Service Bulletin

RATTLE NOISE FROM REAR BRAKE CALIPER

APPLICABLE MODEL(S)/VINS

Bulletin No: 04-001/14	Last Issued: 1/8/2014
© 2014 Mazda Motor of America, Inc.

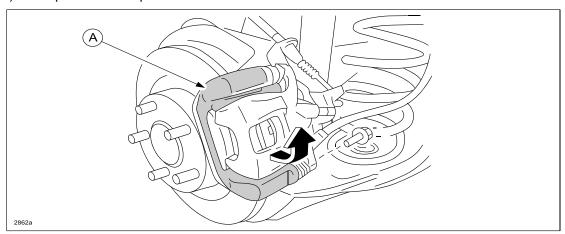
- 1. Verify customer concern.
- 2. When noise is present, lightly depress the brake pedal. Does the noise disappear?
 - a. Yes Proceed to Step 3.
 - b. No This bulletin does not apply. Proceed to step 4.
- 3. Replace the rear brake caliper mounting support (A) and brake pad shim and retainer at the affected side. Refer to MS3 online or Workshop Manual (section 04-11 REAR BRAKE (DISC) REMOVAL/INSTALLATION). Then proceed to step 5.

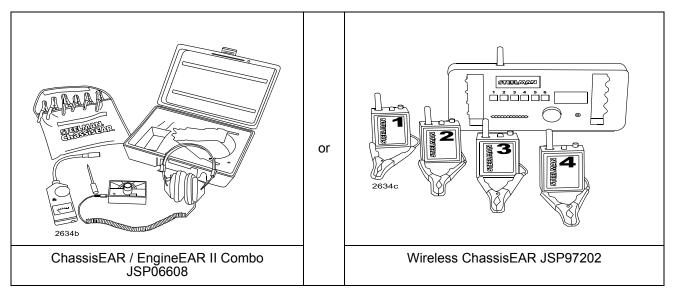
4. Use Special Service Tool (SST) ChassisEAR / EngineEAR II Combo JSP06608 or Wireless ChassisEAR JSP97202 to troubleshoot noise:
